## Decision Notice *Planning Act 2016*

Application No: MCU25/0012  
Street Address: 91 Youngman Street KINGAROY QLD 4610  
Real Property Description: Lot 19 on SP119712  
Planning Scheme: South Burnett Regional Council

Type of Decision: Approval  
Type of Approval: Development Permit for Material Change of Use – Service Station (Extensions)  
Date of Decision: 7 November 2025

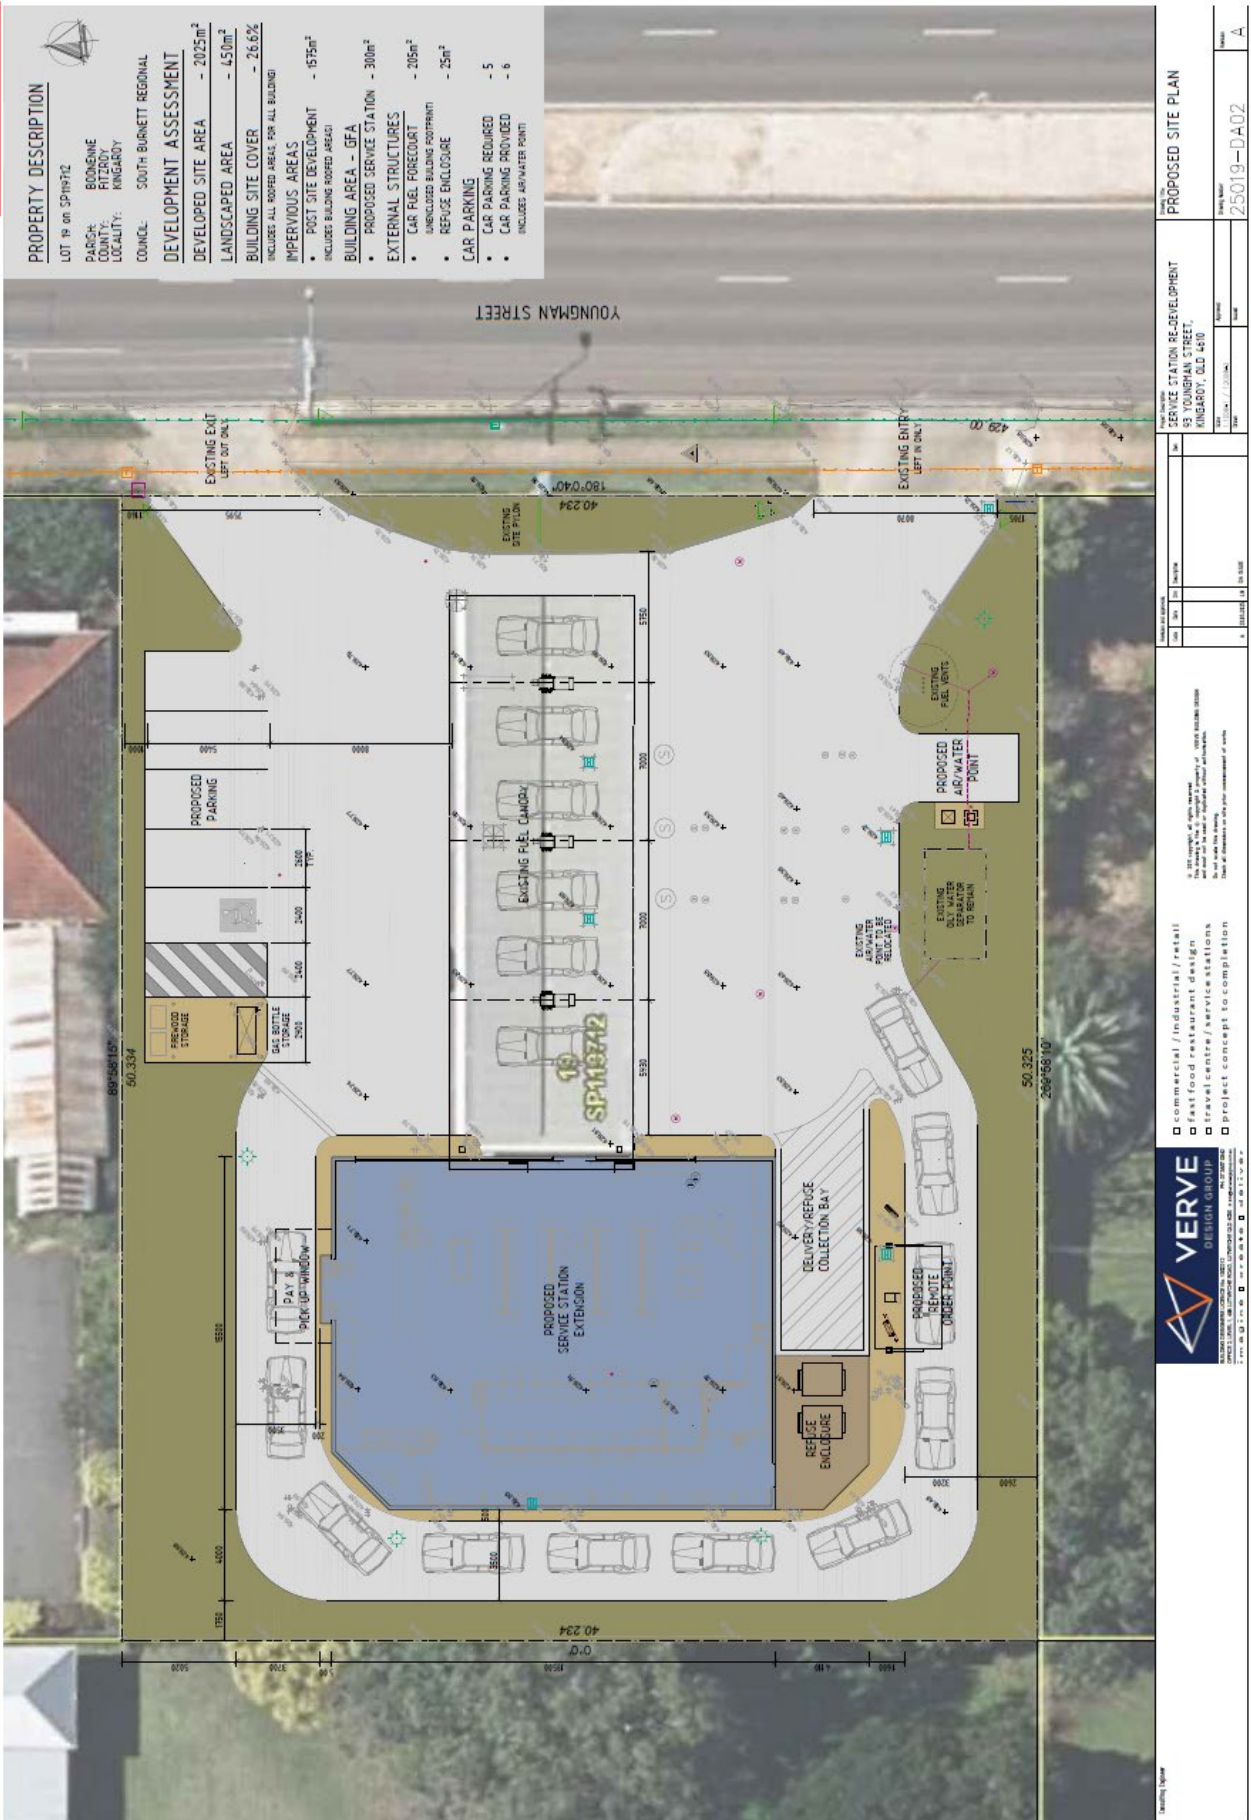
2.	<p>(a) Road access(es) are located generally in accordance with the "Proposed Site Plan" prepared by Verve Design Group dated 23 May 2025, Reference Drawing Number 25019-DA02 Revision A as amended in red.</p> <p>(b) Provide road access works comprising of pavement line marking and Type R2-4 "No Entry Signs", (at the road access location(s) referred to in part (a) of this condition) must be provided generally in accordance with Figure 3.2 of the Traffic Impact Statement prepared by Pekol Traffic and Transport Engineering dated 11 June 2025 Reference 25-598 Revision A.</p> <p>(c) Design and construct the road access works, referred to in part (b) of this condition, in accordance with:-</p> <ul style="list-style-type: none"> <li>I. the Department of Transport and Main Roads' Road Planning and Design Manual, 2nd Edition;</li> <li>II. the Department of Transport and Main Roads' Policies and Technical Specifications;</li> <li>III. the Department of Transport and Main Roads' Standard Drawings Roads; and</li> <li>IV. South Burnett Regional Council requirements where applicable.</li> </ul>	<p>(a) At all times.</p> <p>(b) and (c): Prior to the commencement of use.</p>
